**Sacramento River Flood Control System Evaluation
Initial Appraisal Report - Lower Sacramento Area**

**Environmental Evaluation
August 1993**

PREPARED BY
ENVIRONMENTAL PLANNING BRANCH, PLANNING DIVISION
U.S. ARMY CORPS OF ENGINEERS, SACRAMENTO DISTRICT

**PLANNING AID LETTER
U.S. FISH AND WILDLIFE SERVICE**

FIGURE 4

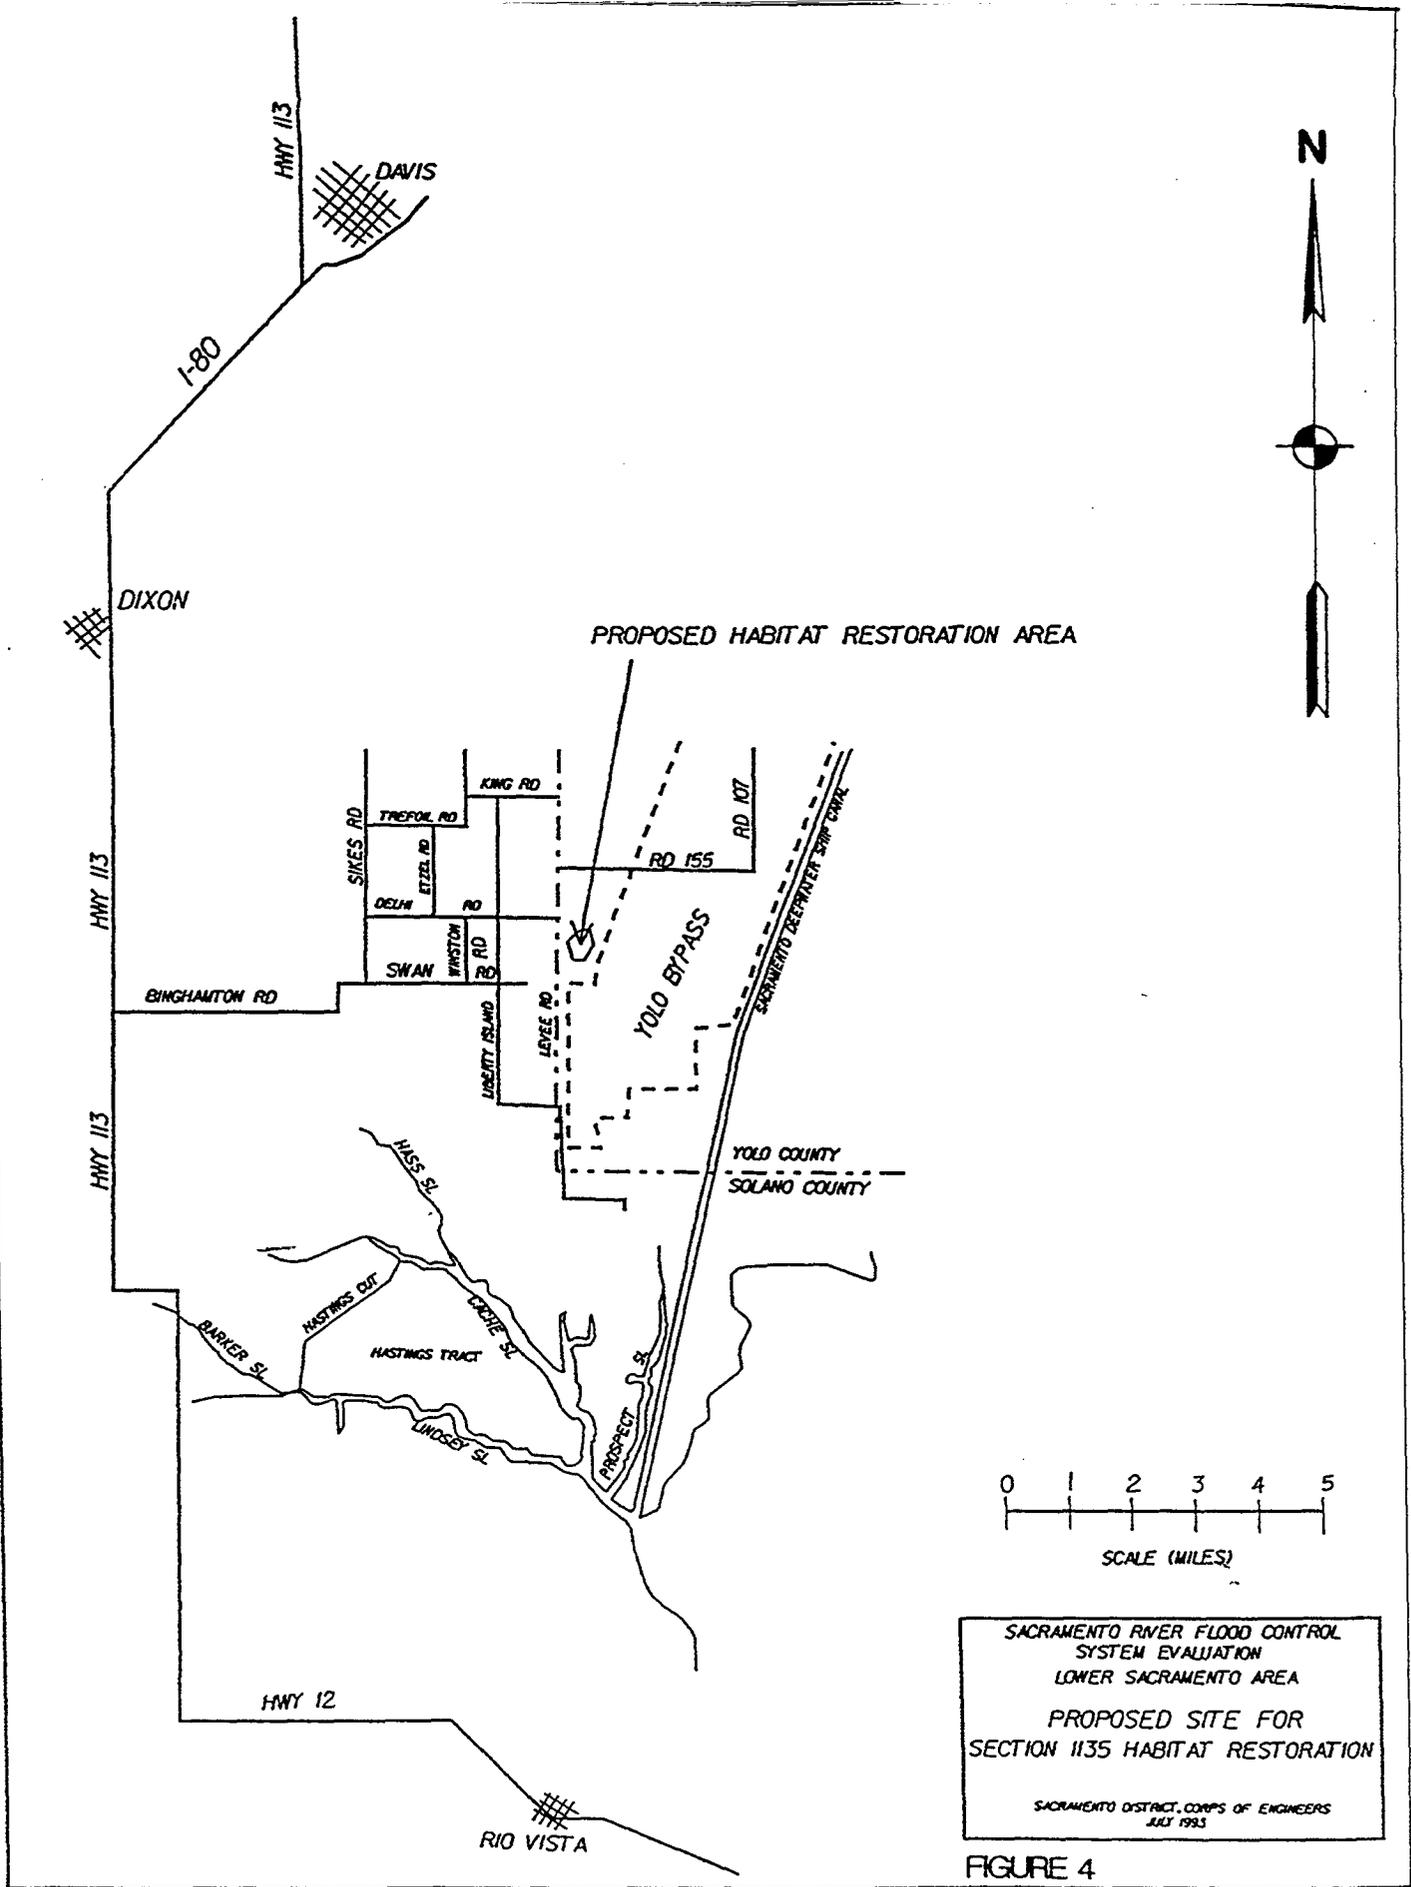
The proposed borrow area in Yolo County and near Delhi Road is a high-value fish and wildlife area (Figure 4). The area is presently intermixed with seasonal and permanent wetlands and therefore provides high wildlife diversity and abundance. Nesting birds using the area include ring-necked pheasants, various waterfowl, northern harriers, and shorebirds.

This area could be enhanced by using the surrounding agricultural lands as a borrow area instead of the proposed borrow area discussed above. Removal of the soil in a mosaic pattern with gentle side slopes would create suitable habitat for planting of emergent wetland and woody riparian vegetation. Borrow should be removed no deeper than 6 feet, and the side slopes should be greater than 4:1. "Islands" of various sizes should be left at the original elevation or raised 3 feet. Planting emergent wetland vegetation in the low areas and woody riparian vegetation in the upland areas would provide ideal conditions to increase the habitat value of the area. This Section 1135 habitat restoration project would allow borrow extraction and mitigation development to be done in concert.
